CATS-M Transit Training Company HQ Bldg. 1270 Construction Project

PROJECT NO. 31090572

A D D E N D U M N O . 2

8 8'H CHAIN LINK FENCE, TYP (ABI #1)
1/2" = 1'-0"

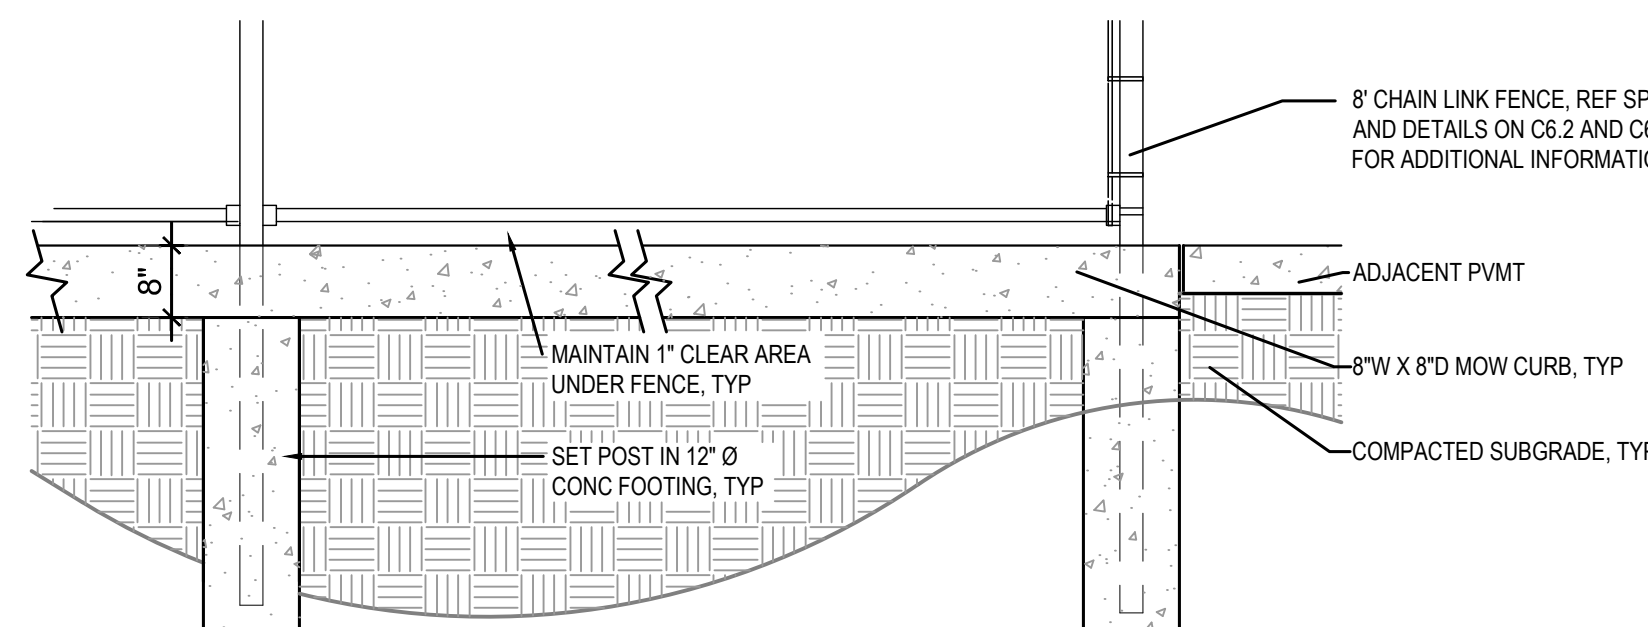
1. Sheet C2.1 – Site Layout Plan.
 - a. This sheet has been reissued in its entirety. Added note for concrete mow curb for ABI #1.
2. Sheet C6.1 – Site Details.
 - a. This sheet has been reissued in its entirety. Added note for concrete mow curb for ABI #1.
3. Sheet S1.1 – Structural Design Data, General Notes, Schedules and Standard Details
 - a. See attached Sheet S1.1 with the addition of utility trenches below footings and floor slab subgrade preparation instructions.
